**Technical Service
Information Bulletin**

RATTLE NOISE FROM HEADLINER AREA

'07 ES 350

NVH
NV008-06

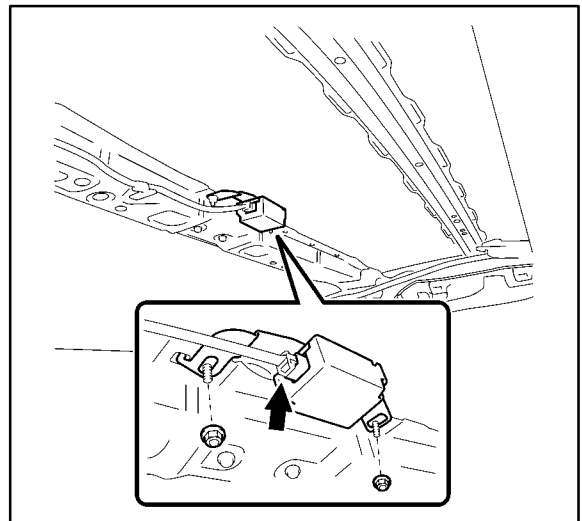
3. Remove the tire pressure warning receiver assembly.
 - A. Disconnect the connector.
 - B. Remove the two nuts and the tire pressure warning receiver assembly.

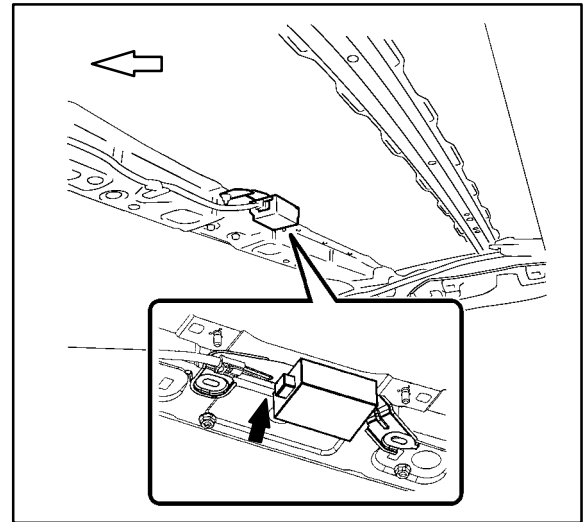
To improve this condition, the rigidity of the bracket holding the TPWS Antenna to the roof cross brace has been increased. Replace the older style receiver assembly with the new type assembly on vehicles built PRIOR to the starting VIN shown below.

4. Install the NEW tire pressure warning receiver assembly.
 - A. Install the tire pressure warning receiver assembly with the two nuts.

**Torque: 7.5 N•m
(77 kgf•cm, 66 in.•lbf)**
 - B. Connect the connector.
5. Install the roof headlining assembly.
